Access Report

**State Significant Development Application
Residential Flat Building**

3A, 3B, 5A and 7 Burgoyne Street and 1 and 3
Pearson Avenue and 4 Burgoyne Lane
GORDON NSW 2072

Introduction – SSDA Response to Submissions

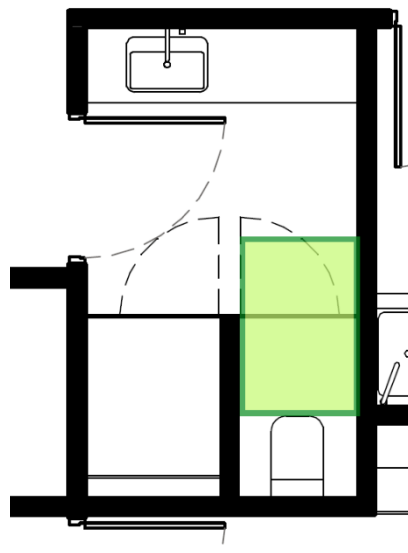
<p>should provide a minimum clear width of 1000mm.</p> <p>* Corridor widths should be measured as described in Clause 6.3 of AS 1428.1 – 2009</p>		
<p>4 - Toilet</p> <p>a. Dwellings should have a toilet on the ground (or entry) level that provides:</p> <ul style="list-style-type: none"> i. a minimum clear width of 900mm between the walls of the bathroom if located in a separate room; and ii. a minimum 1200mm clear circulation space forward of the toilet pan exclusive of the swing of the door in accordance with Figure 3(a). iii. The toilet pan should be located in the corner of the room (if the toilet is located in a combined toilet / bathroom) to enable installation of grabrails at a future date. <p>Reinforcement guidelines for walls in bathrooms and toilets are found in element 6.</p>	<p>Can readily comply</p> <p>Toilets are typically shown in corners and include a circulation space of 900x1200mm clear of any door swing. The length of wall adjoining the toilet can facilitate future grabrail installation.</p> <p>Where toilets adjoin showers, a solid wall shall be provided for fixing of grabrails in accordance with Silver LHA Element 6.</p> <p>Some apartment floorplans include shelves or other elements that may result in inadequate circulation space to the toilet pan. These layouts shall be rationalised at CC stage to ensure compliance with this clause. See example below from unit A-2.08:</p>  <p>Some apartment floorplans include swinging doors within the circulation zone of the WC. These doors should be changed to sliding doors or the WC and shower should be swapped so the door swing remains clear of the WC circulation zone. See example from unit A-4.05:</p>	<p>Y</p>

The amendments above can be readily implemented at CC stage without impacting general apartment layout.

A-7.02:

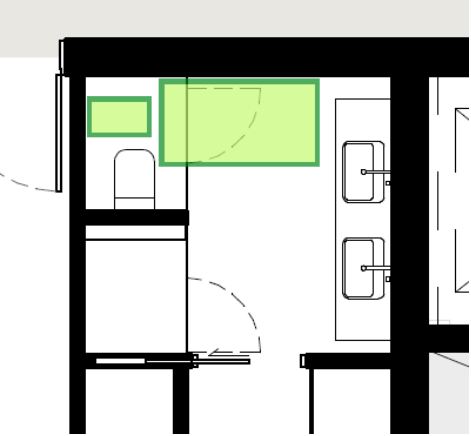
Several bathrooms include screens to WC's that restrict the required circulation requirements. These shall be removed or reconfigured at CC stage to ensure adequate circulation. The rooms are large enough and readily capable of compliance with this clause. Examples below:

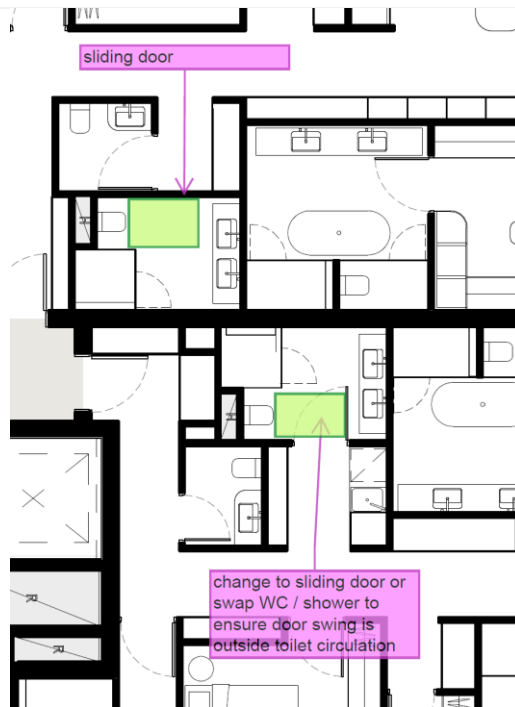
Dwelling entrance doors are typically 970mm doors capable of complying with this clause. A 1500x1500mm landing is provided to all Platinum dwelling entry doors. Thresholds are level. Entrances are connected to accessways nominated in Element 1.
